Chapter 3
Items 3-2-12 through 3-24-12
August 21, 2014.

This is one of eight documents containing the preliminary actions of the A117.1 Committee regarding public comments received on the First Public Review Draft (October 2013) of proposed changes to the A117.1 Standard, 2009 edition. Each item was discussed at the meeting of Committee during the weeks of January 21st and July 14th of 2014, in Washington D.C. The Committee took action on each public comment and such action is specified herein. The actions listed here are subject reconfirmation by the Committee via the Committee's ballot process.

Committee Action Report on Public Comments Received on First Public Review Draft
January 21-24, 2014 and July 14-16, 2014

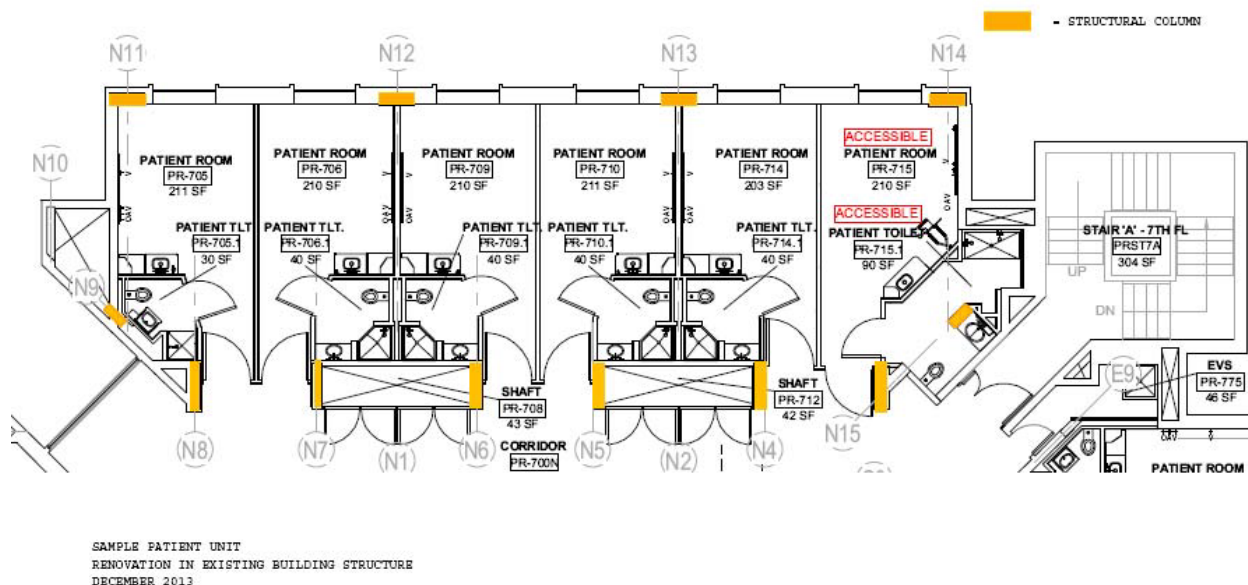
The example below shows a design for a new inpatient bed unit in an existing structure. One of the required accessible rooms is on the right, and clearly shows moving outside the "box" of the other regular rooms. These additional requirements noted above would add to this situation. Also, note that the existing structure forces the accessible toilet room to be fragmented. Although maintaining the required clearances at each fixture, the columns and structure of the stair make for a highly inefficient layout.

ATTACHMENT B TO AMERICAN HOTEL & LODGING COMMENTS
 IMPACT OF PROPOSED CHANGES TO TURNING RADIUS

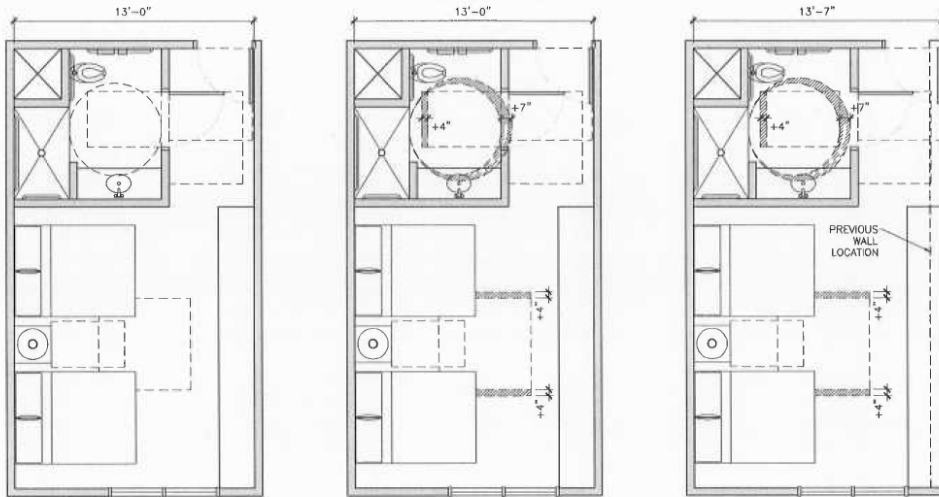
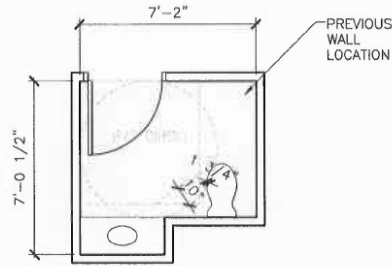
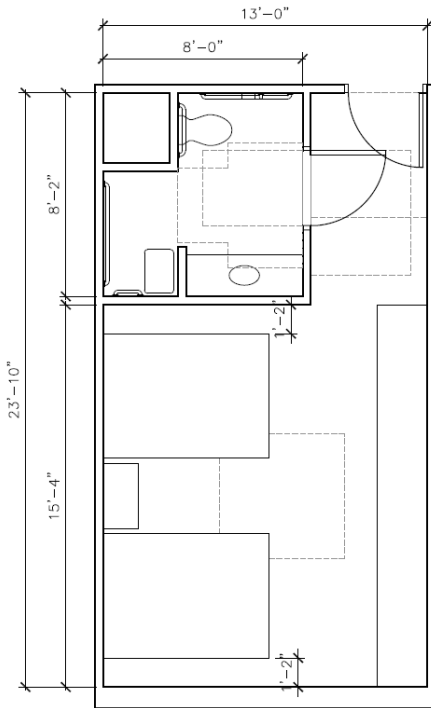
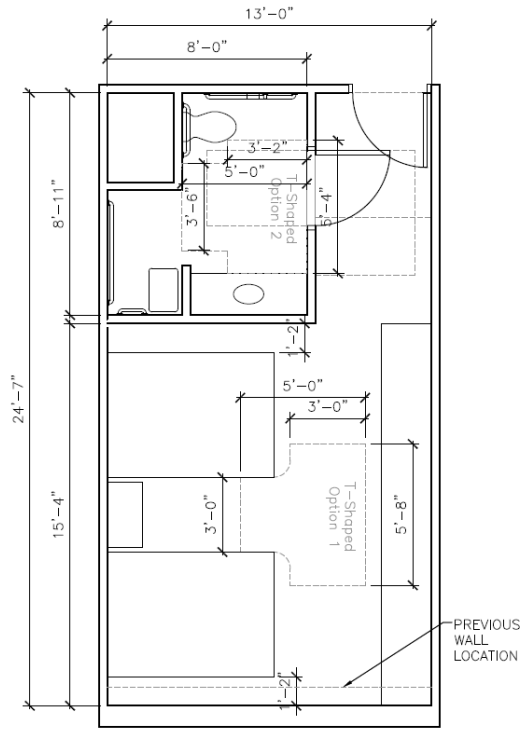
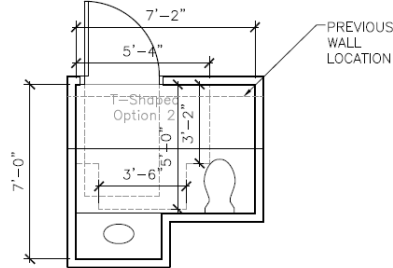
Attachment B contains some preliminary drawings showing the impact of the larger proposed turning radius and clear floor space requirement on a typical accessible guestroom, a single user restroom and a U-shaped kitchen. See Attachment B. The drawings show that the enlarged turning radius will require a typical 13' wide accessible guest room to be at least 7" wider and 14 square feet larger overall. Because a typical hotel is required to have a number of accessible guest rooms (approximately three percent (3%) of inventory), the impact will be very significant. Single-user restrooms will have to be at least 4.5 square feet larger and U-shaped kitchens will have to be at least 8 square feet larger. Every access aisle for accessible parking spaces also will have to be 7" wider, thereby decreasing the overall number of parking spaces that can be provided on a site.

The impact on existing facilities will be even more serious because the diagrams plainly show that there would be no way to comply with the new turning space requirement in future renovations within the existing footprint of the rooms. Accessible rooms and restrooms are typically built just large enough meet current accessibility requirements. The owners of existing facilities seeking to renovate will either have to demolish existing walls to create new room footprints that will reduce room count, or seek variances from local building officials who may or may not agree to issue them. The process of seeking variances will inject additional delays, cost, and uncertainty to the renovation process.

Another very significant proposed change to the T-turn provision is the elimination of an existing provision that allows a portion of the T-turn space to overlap the knee/toe clear space that must be provided under an obstruction such as a bathroom vanity. As shown in Attachment C, this deletion, when combined with the increased space requirements for a T-turn, results in an accessible guest room that must be approximately 10 square feet larger. In a single user restroom, the proposed T-turn changes would require an increase of 3.5 square feet to a typical single user restroom.

The impact of the T-turn change is especially problematic in the accessible guestroom scenario because the length of the entire room would have to be increased by 9", making the accessible room longer than the standard room. This is an untenable situation in both new construction and alterations. In new construction, the lengthening of one room type would cause all other rooms on that corridor to be deeper, resulting in decreased room count. In existing facilities, there would be no way to lengthen the room because doing so would intrude into the corridor. Thus, the better option for providing a turning space in this room configuration is to use the 67" radius shown in Attachment B which would require the room to be 14 square feet larger.

- INCREASE IN ROOM SIZE: 14 SQ. FT.
- COST PER SQ. FT. OF CONSTRUCTION: X
- ADDITIONAL COST PER ROOM = 14 x X

- INCREASE IN ROOM SIZE: 4.5 SQ. FT.
- COST PER SQ. FT. OF CONSTRUCTION: X
- ADDITIONAL COST PER ROOM = 4.5 x X

- INCREASE IN ROOM SIZE: 5 SQ. FT.
- COST PER SQ. FT. OF CONSTRUCTION: X
- ADDITIONAL COST PER ROOM = 5 x X

- INCREASE IN ROOM SIZE: 10 SQ. FT.
- COST PER SQ. FT. OF CONSTRUCTION: X
- ADDITIONAL COST PER ROOM = 10 x X

- INCREASE IN ROOM SIZE: 3.5 SQ. FT.
- COST PER SQ. FT. OF CONSTRUCTION: X
- ADDITIONAL COST PER ROOM = 3.5 x X

Figure 304.3.1

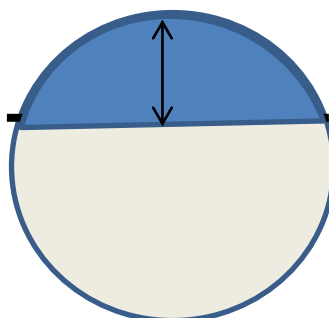
1. The depth of the overlap shall not be more than 10 inches (255 mm), and
2. The depth shall not exceed the depth of the knee and toe clearances provided, and
3. The overlap shall be permitted only within the turning circle area shown shaded in Figure 304.3.1.

Figure 304.3.1

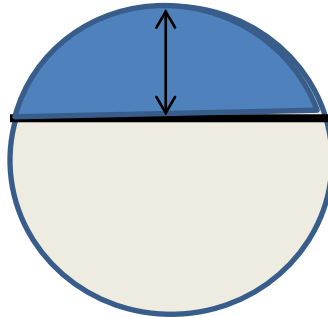
304.3.1 Circular Space. The turning space shall be a circular space with a ~~60-67~~ inch (~~1525 1700~~ mm) minimum diameter. The turning space shall be permitted to include knee and toe clearance complying with Section 306. Where the turning space includes knee and toe clearances under an obstruction, the overlap shall comply with all of the following:

- ~~1. The depth of the overlap shall not be more than 10 inches (255 mm), and~~
- ~~2 1.~~ The depth shall not exceed the depth of the knee and toe clearances provided, and
- ~~3 2.~~ The overlap shall be permitted only within the turning circle area shown shaded in Figure 304.3.1.

Reason: The intent of the original proposal was to eliminate the 'donut' effect currently permitted with the turning circle. However, in order to be consistent with the T-turn in Section 304.3.2, the depth on that one side should be permitted to be the same depth as the knee and toe clearance provided.

Figure 304.3.1

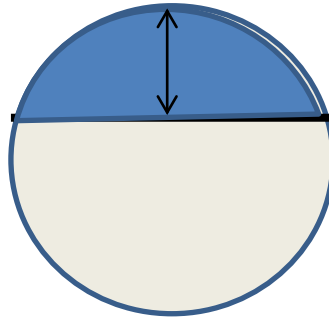
306. Where the turning space includes knee and toe clearances under an obstruction, the overlap shall comply with all of the following:

1. The depth of the overlap shall not be more than 10 inches (255 mm), and
- ~~2. The depth shall not exceed the depth of the knee and toe clearances provided, and~~
- ~~3. The overlap shall be permitted only within the turning circle area shown shaded in Figure 304.3.1.~~

Figure 308.4.1(a)

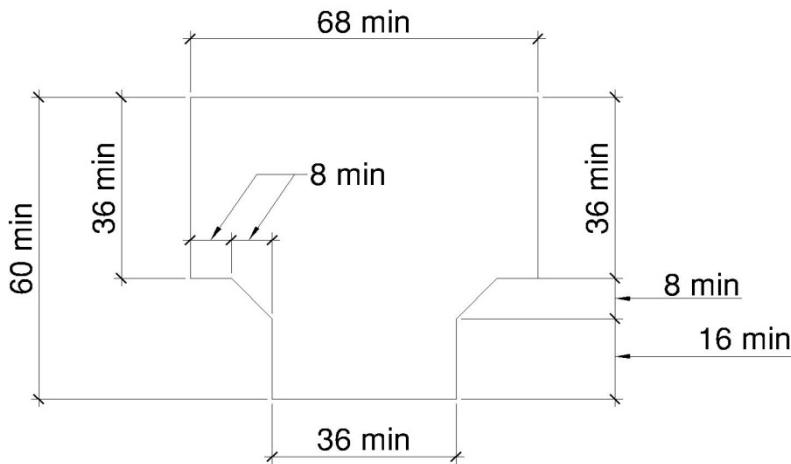
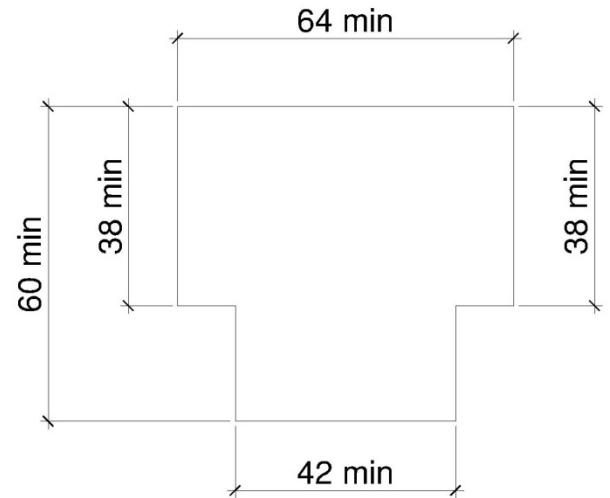
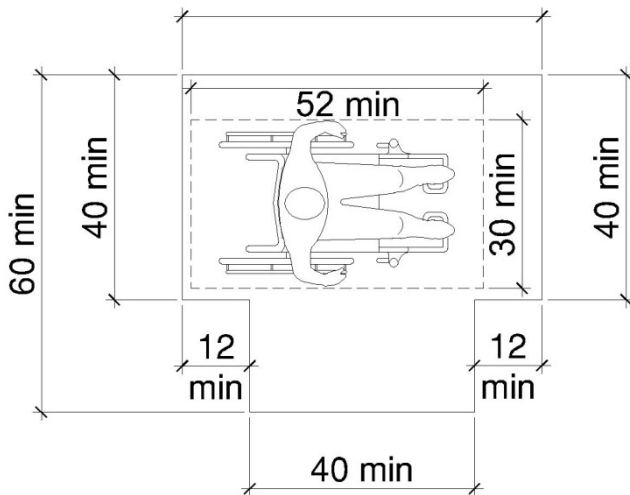
The revisions to the three options in 304.3.2 for the T-turn is to do the following

- Uses a consistent language for the three options
- Corrects the dimensional error in the third option.
